PLANNING COMMISSION

SUBJECT: PUBLIC HEARING – PLANNED UNIT DEVELOPMENT (File Number PUD 004) – Big Beaver Center (formerly "The Monarch") PUD, North side of Big Beaver Road between Alpine and McClure, Section 20, Currently Zoned PUD 004 and R-1B (One Family Residential) Districts

Concept and Preliminary Planned Unit Development and Preliminary Site Plan Review For City of Troy, Michigan

Applicant	A.F. Jonna Development Company
Project Name:	Big Beaver Center: northeast quadrant
Plan Date:	July 10, 2012
Location:	Northeast corner of Big Beaver Road and Alpine
Zoning:	PUD and R1-B One Family Residential
Action Requested:	Planning Commission review and recommendation to the City Council for approval of the Concept Development Plan, Preliminary Development Plan, and Preliminary Site Plan Review.
Required Information:	Deficiencies noted.

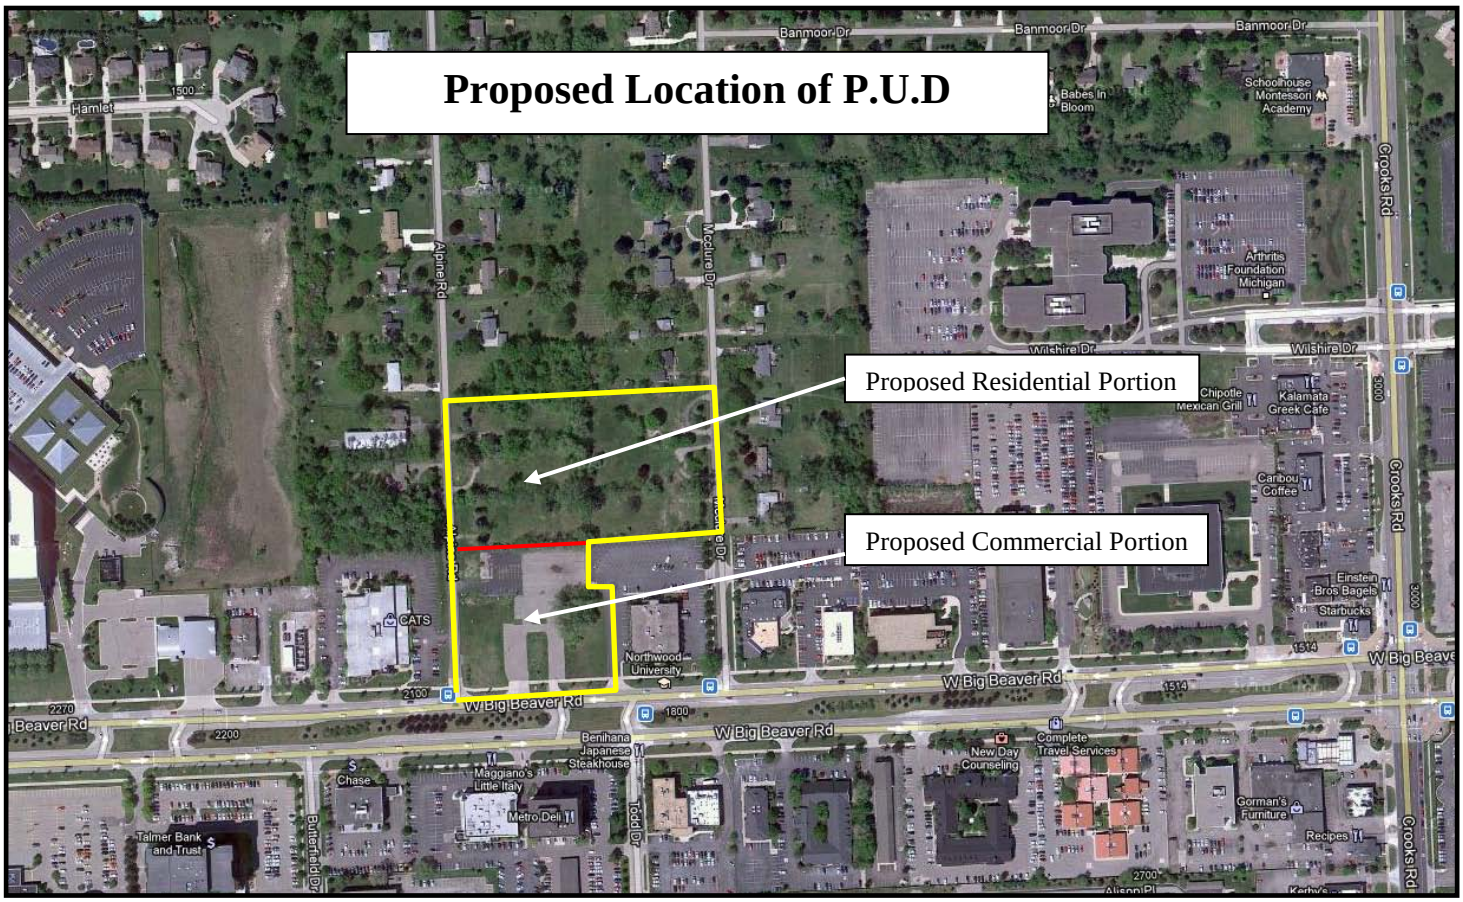
The applicant is proposing a Planned Unit Development (PUD) on an existing vacant 7.5 acres site. The 2.54 acre commercial portion of the site has no buildings but some portions are improved with asphalt. The 4.96 acre residential portion is entirely vacant.

The proposed PUD includes 27,397 square feet of retail space in two (2) buildings and sixteen (16) single-family lots. The commercial portion includes a 3,397 sq/ft free-standing drive-thru bank and a 24,000 sq/ft retail building, which can be divided into multiple store fronts. The applicant proposes to construct a new street between Alpine Road and McClure Road, parallel to Big Beaver Road, which the new 16 detached single-family lots will front on.

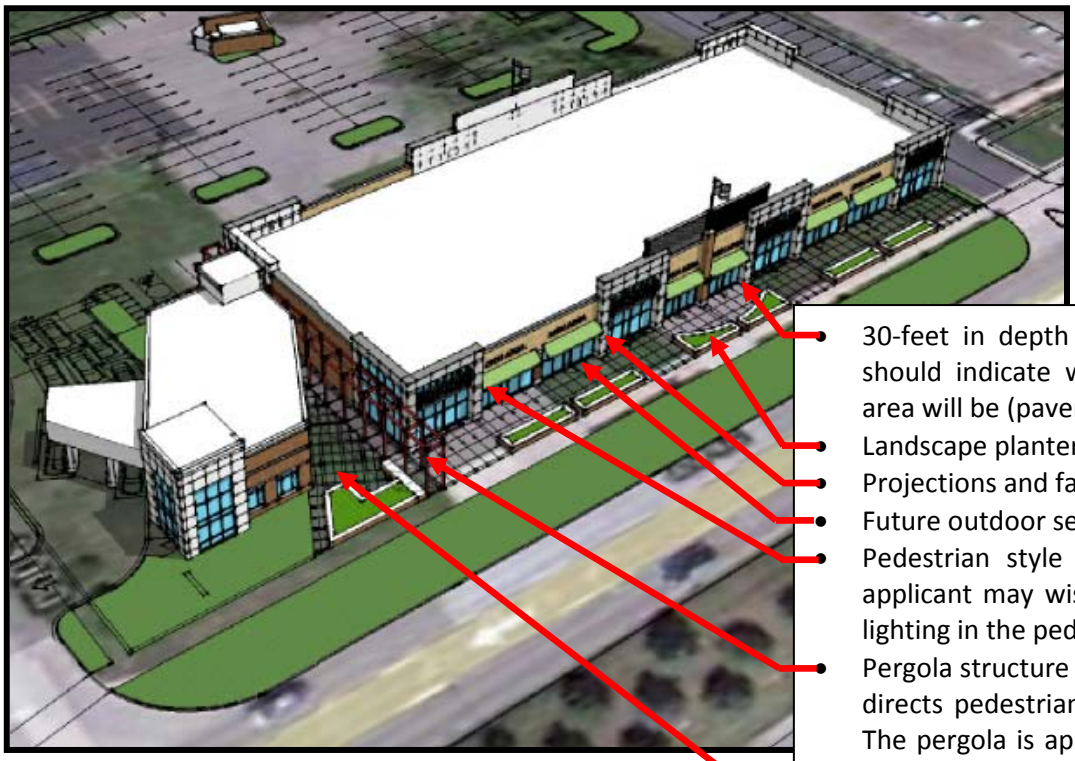
The applicant is proposing a significant benefit via pedestrian enhancements along Big Beaver Road. In addition to architectural details that invite and encourage the pedestrian, the applicant is also improving the "Pedestrian Realm (area between building and roadway)" with the following features:

- 30-feet in depth of pedestrian area. The applicant should indicate what the proposed material of this area will be (pavers, stamped concrete, etc).
- Landscape planter boxes
- Projections and façade articulation
- Future outdoor seating
- Pedestrian style and scaled building lighting. The applicant may wish to consider pedestrian style pole lighting in the pedestrian realm as well.
- Pergola structure that serves not only as public art but directs pedestrians to the back side of the buildings. The pergola is approximately 17 feet in height, made of galvanized steel, and painted red.
- Plaza in front of bank

Items to be Addressed: *1). Indicate the material used as part of the expanded sidewalk; 2). Consider pedestrian style pole lighting in pedestrian realm; 3). Extend the proposed sidewalk along Alpine Drive to the northern project line; and 4). Provide a sidewalk along McClure Road from its present termination to the northern project line.*

1 / A012 COMPOSITE SITE PLAN

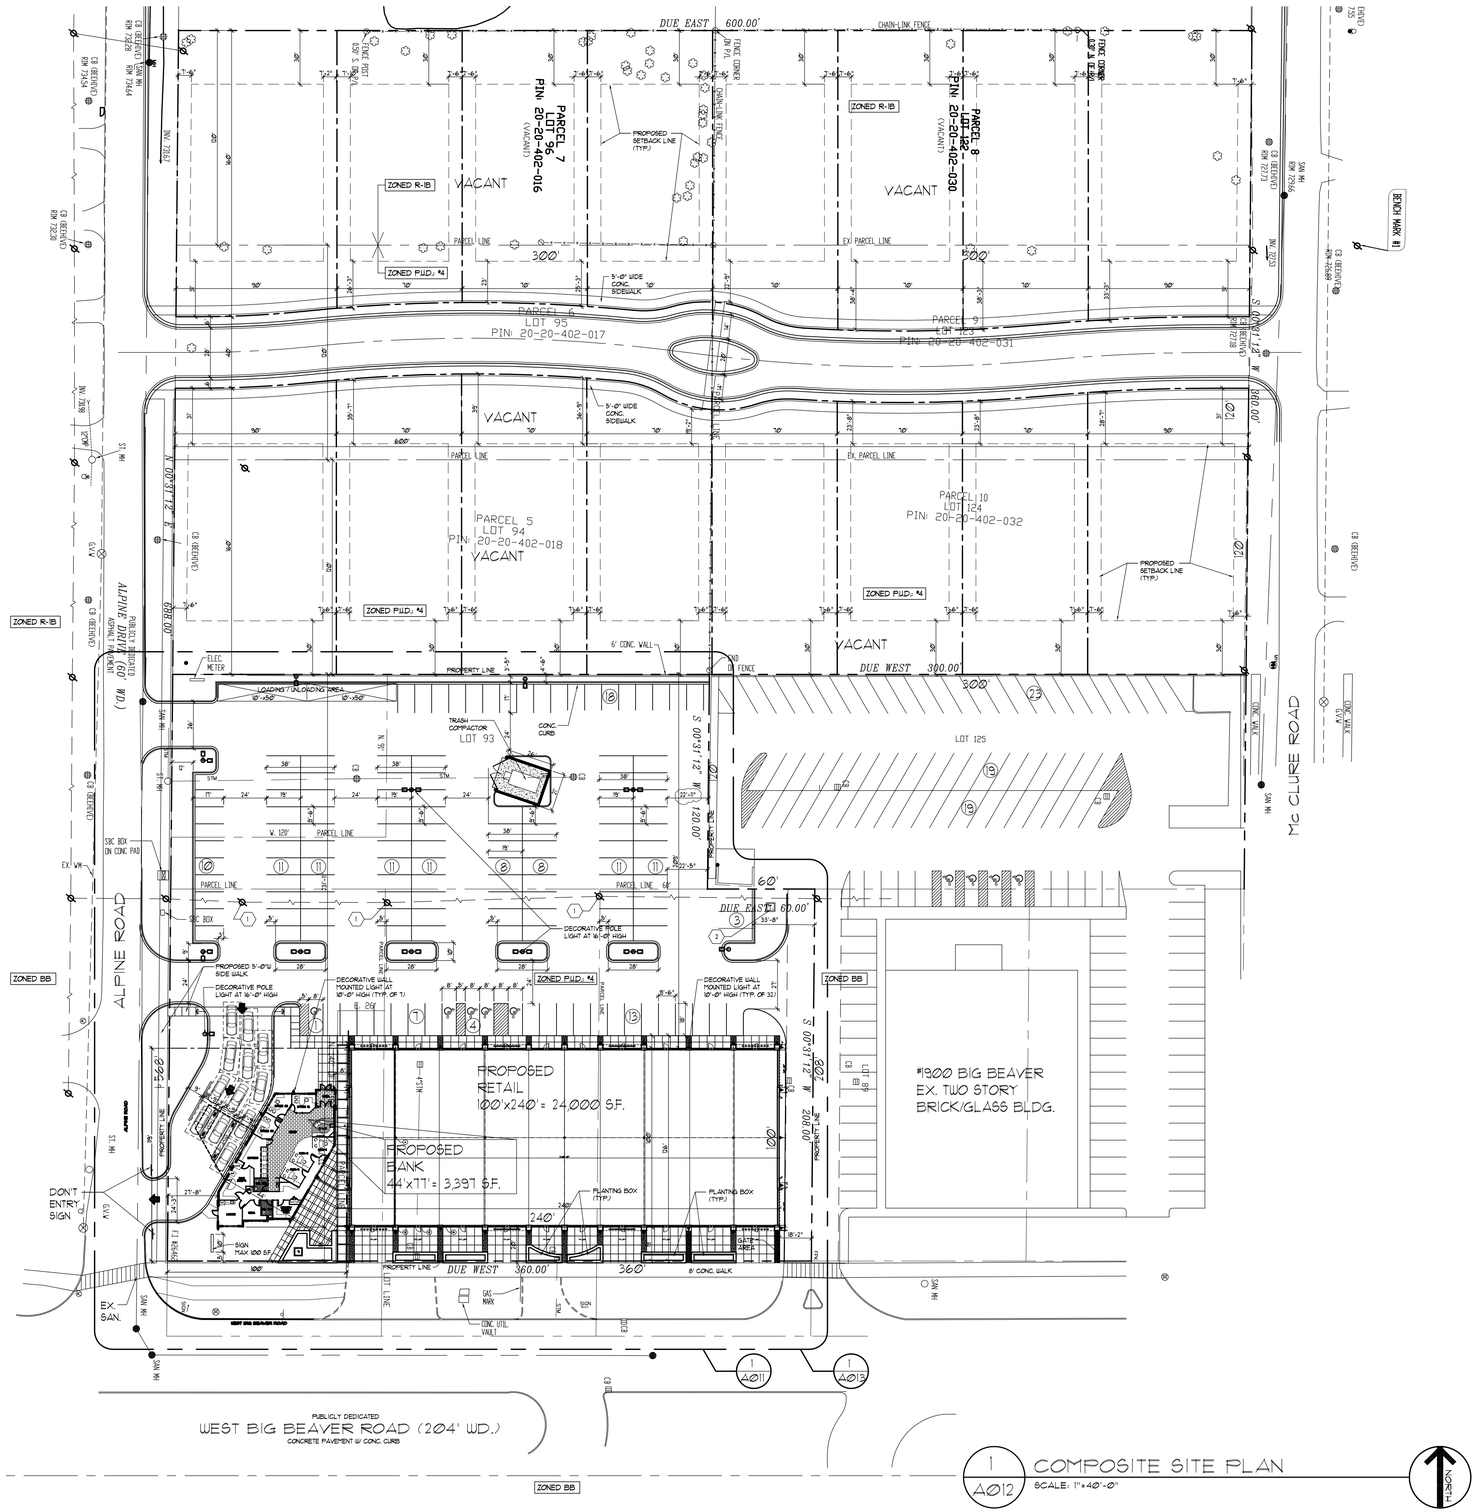
Thought the site plan shows dimensions on Sheet A0.1.2; the applicant has not provided a zoning calculation table. Such table should be provided by applicant. Physical standards relating to matters such as building height, bulk, density, parking and setbacks will be determined based upon the specific PUD plan presented. However, for Planning Commission consideration, we have compared the proposed residential to the surrounding R1-B dimensional requirements:

1 / A031 PHOTOMETRIC PLAN

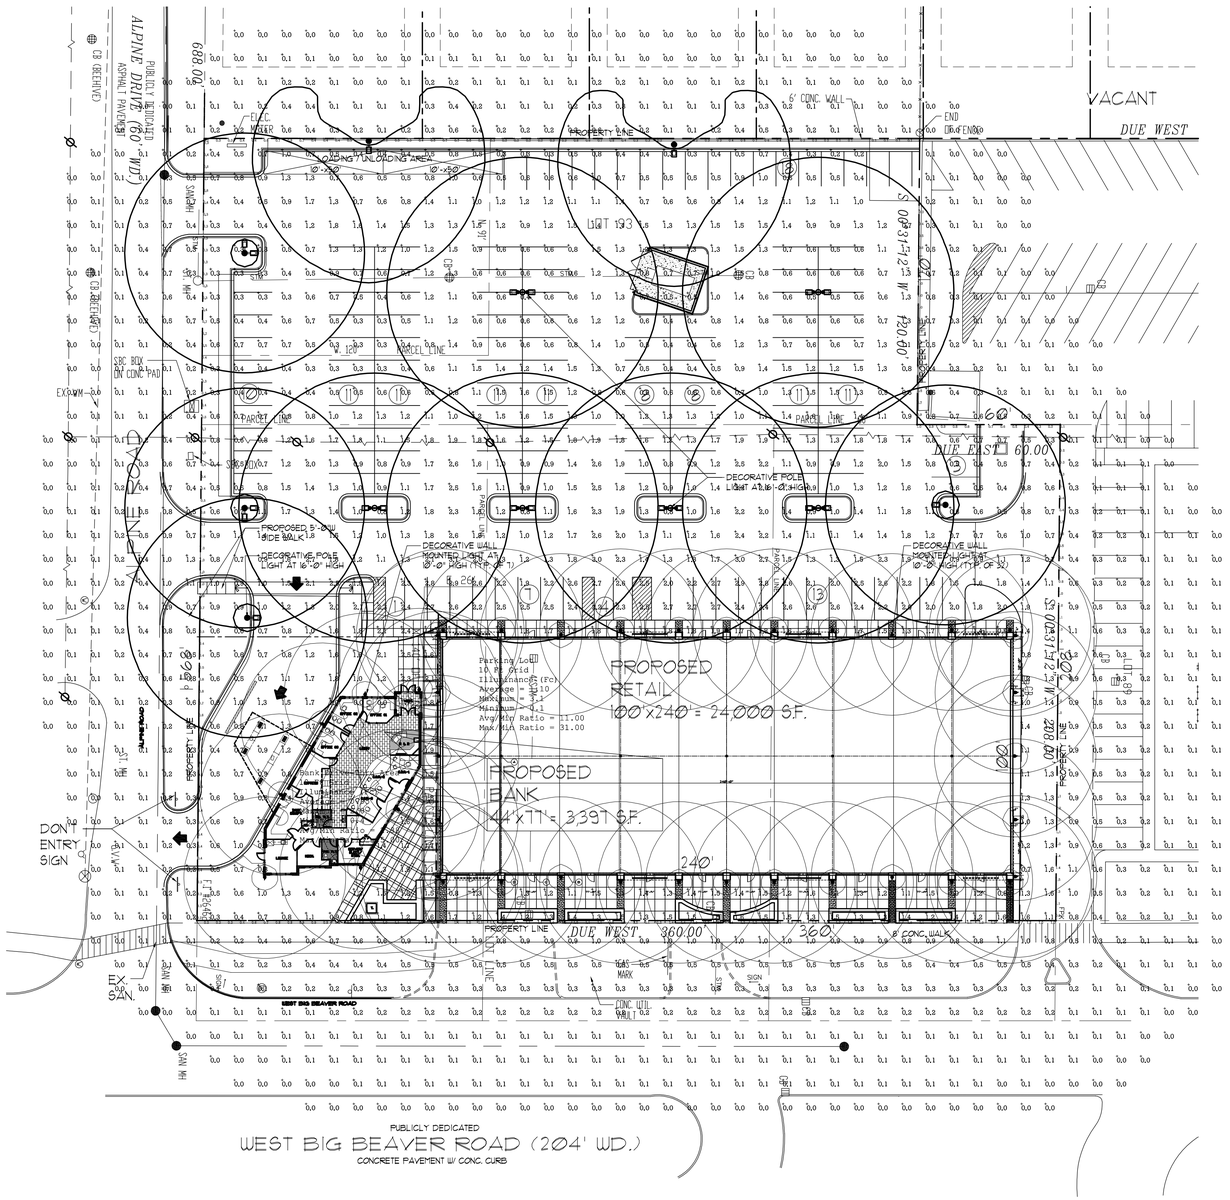
The applicant has provided a lighting (photometric) plan. The applicant shall reduce the maximum lighting to no greater than 20 foot candles. Furthermore, the applicant shall turn-off or reduce lighting between the hours of 11:00 p.m. and sunrise. The applicant meets photometrics requirements at the property line.

It is difficult to tell from the plans which fixtures are being used in what locations. The photometric plan should more clearly indicate the proposed fixture locations, including the use of pedestrian scale pole lighting the pedestrian realm.

Items to be Addressed: *1). The applicant shall reduce the maximum lighting to no greater than 20 foot candles; 2). Lights shall be turned-off or reduced between the hours of 11:00 p.m. and sunrise; and 3). A revised photometric plan should be submitted which more clearly indicate the proposed fixture locations, including the use of pedestrian scale pole lighting the pedestrian realm.*
